INTERNAL CORRESPONDENCE

SUBJECT: ECO Matrix and rework for IPB, IOC, DRR Boards REV 3

This document contains the rework required to up-grade the IOC, IPB, DRR Channel and interface boards to the latest correct dash and REV level.

2699A (CONT'D) PWB 1001242-04 REV. 8 & 11 ONLY.

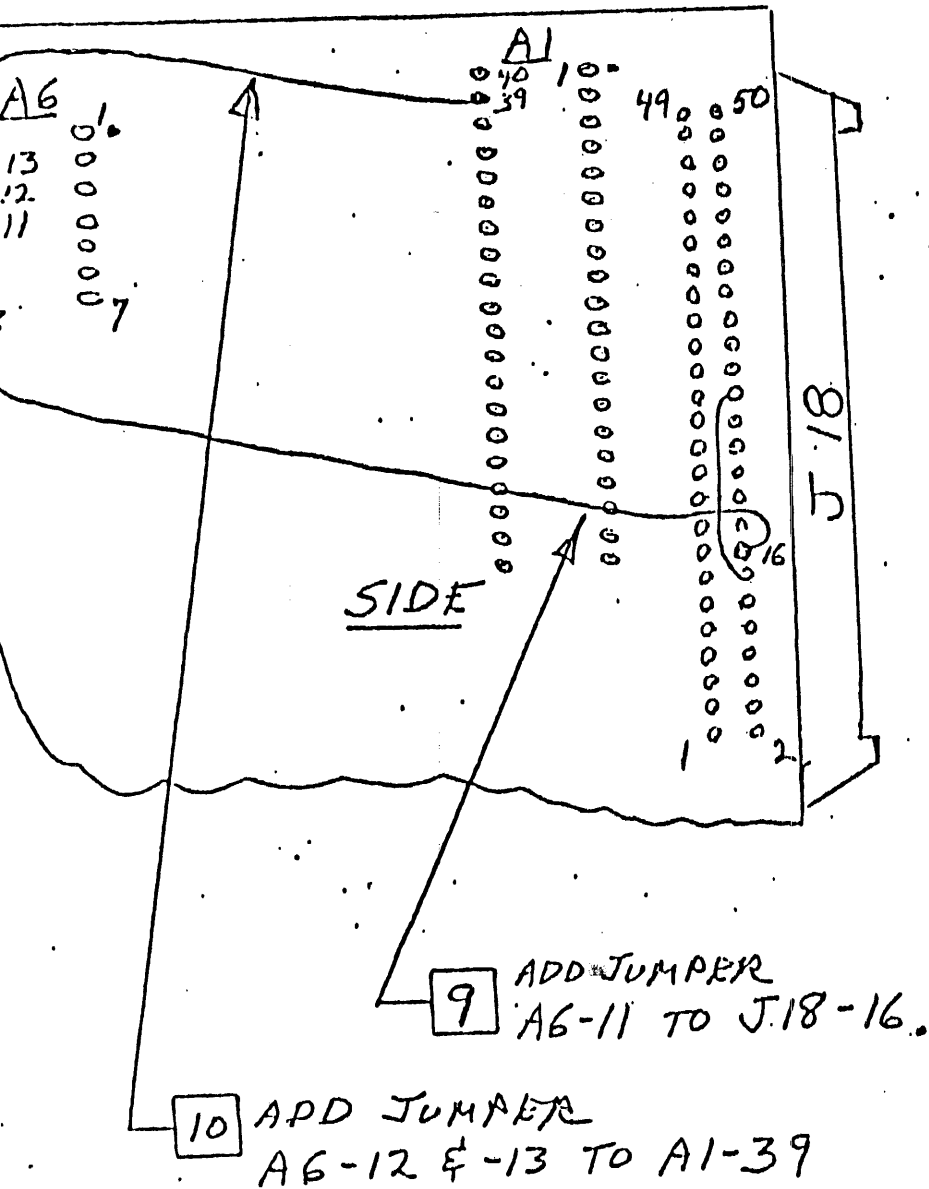
11 ADD (1EA) 470 Ω RESISTOR
P/N 56-019 FROM A68-6 TO
A68-16 (COMPONENT SIDE).

11 ADD 470 OHM RESISTOR
(56-019) A68-6 TO A68-16

REWORK INSTRUCTION: (CONT'D)ECO 2699 A (CONT'D) NOTE: FOR 1001242-04 REV. 8, 11, 12 & 13.

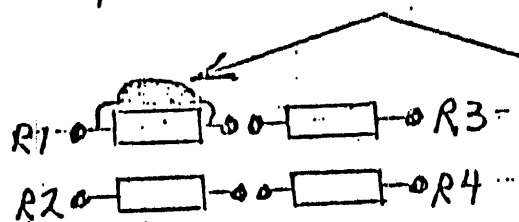
STEP 12 ADD CAPACITOR C-90 IN PARALLEL TO RESISTOR R1.
P/N. 64-007 CAP. CER, .01UF $\pm \frac{80}{20}\%$ 25V.

12 ADD CAPACITOR IN.
PARALLEL TO R1

ECO 1630 - PWA 101241-04 REV. 12 TO REV. 13, USING PWB 1001242-04 REV 8.

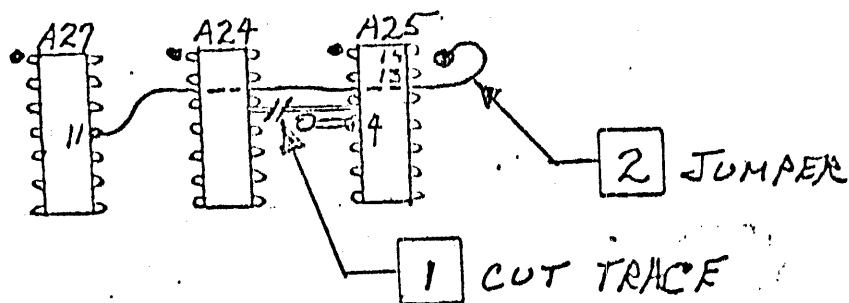
- STEP **1** CUT TRACE ABOVE FEEDTHRU BESIDE A25-4 (COMPONENT SIDE).
 STEP **2**, ADD JUMPER FROM A27-11 TO FEEDTHRU BESIDE A25-13 (COMP. SIDE),
 RUNNING WIRE UNDER A24 & A25.

- STEP **3** MARK ECO 1630 ON SOLDER SIDE OF BOARD.

2.699A (CONT'D) PW13 1001242-04 REV. 8 & 11 ONLY

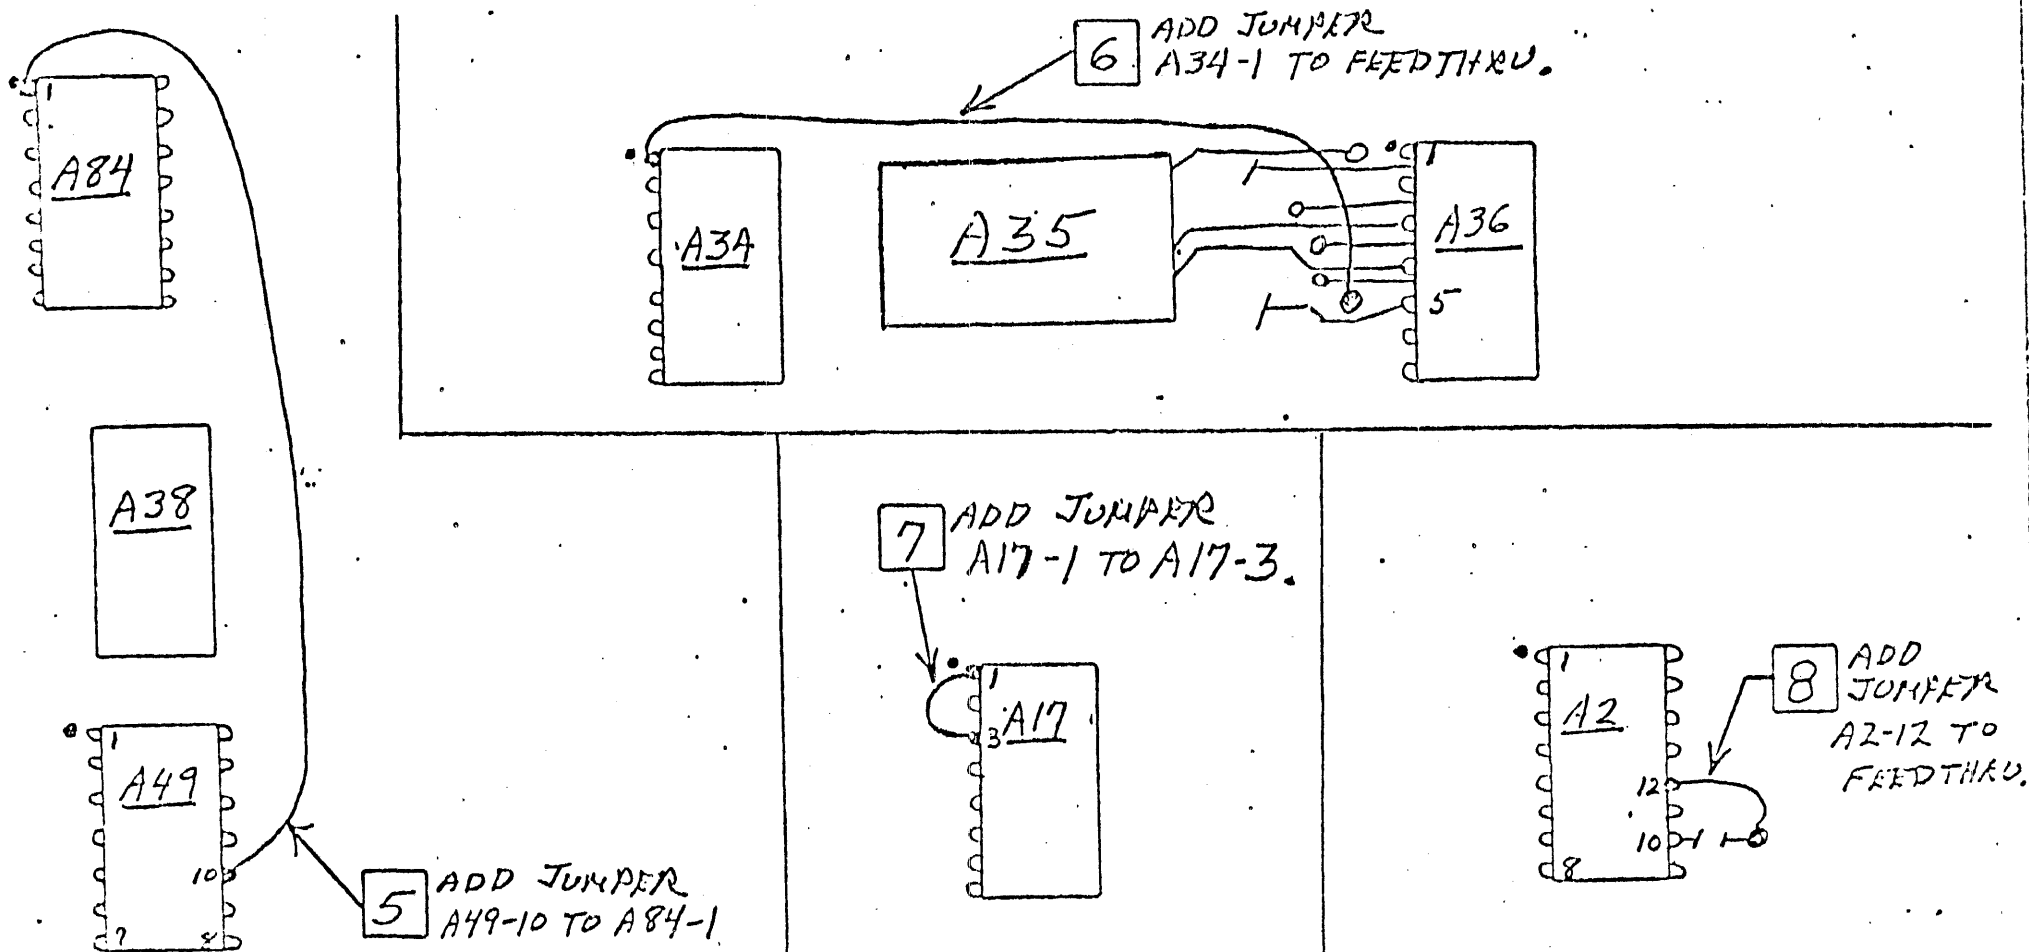
- STEP 5 ADD JUMPER FROM A49-10 TO A84-1. (COMPONENT SIDE).
- STEP 6 ADD JUMPER FROM A34-1 TO FEED THRU ADJACENT TO A36-5 (COMP. SIDE).
- STEP 7 ADD JUMPER FROM A17-1 TO A17-3 (COMPONENT SIDE).
- STEP 8 ADD JUMPER FROM FEEDTHRU ADJACENT TO A2-10 TO A2-12 (COMP. SIDE).
- STEP 9 ADD JUMPER FROM A6-11 TO J18-16 (SOLDER SIDE).
- STEP 10 ADD JUMPER FROM A6-12 & 13 TO A1-39 (SOLDER SIDE).

2699A (CONT'D) PWB 1001242-04 REV. 8 & 11 ONLY.

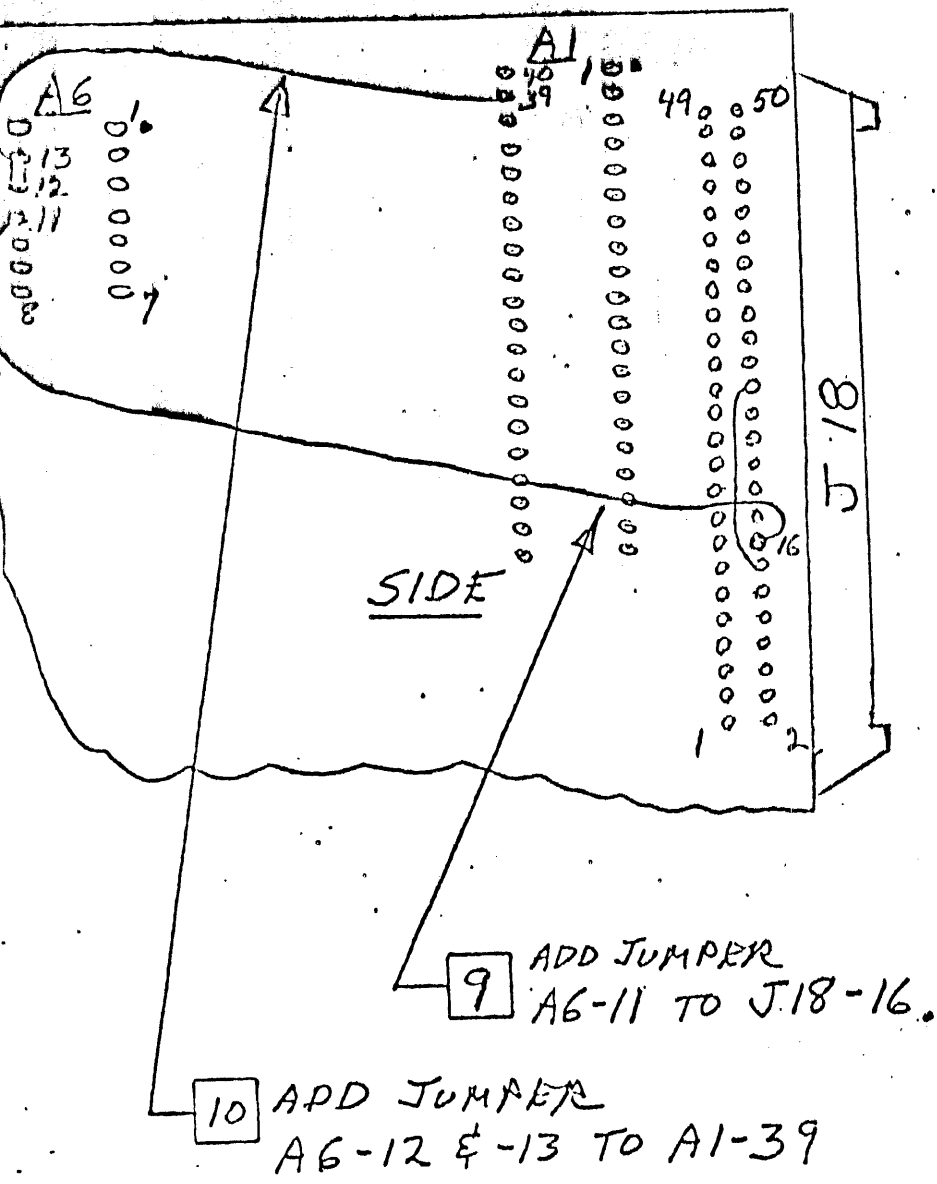
STEP 11 ADD (1EA) 470 Ω RESISTOR
P/N 56-019 FROM A68-6 TO
A68-16 (COMPONENT SIDE).

11 ADD 470 OHM RESISTOR
(56-019) A68-6 TO A68-16

ECO 2699 A (CONT'D) NOTE: FOR 1001242-04 REV. 8, 11, 12 & 13.

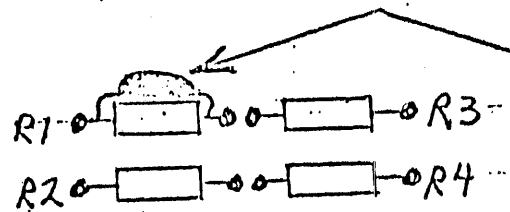
STEP 12 ADD CAPACITOR C-90 IN PARALLEL TO RESISTOR R1.
P/N. 64-007 CAP. CER, .01UF $\pm 80\%$ 25V.

12 ADD CAPACITOR IN.
PARALLEL TO R1
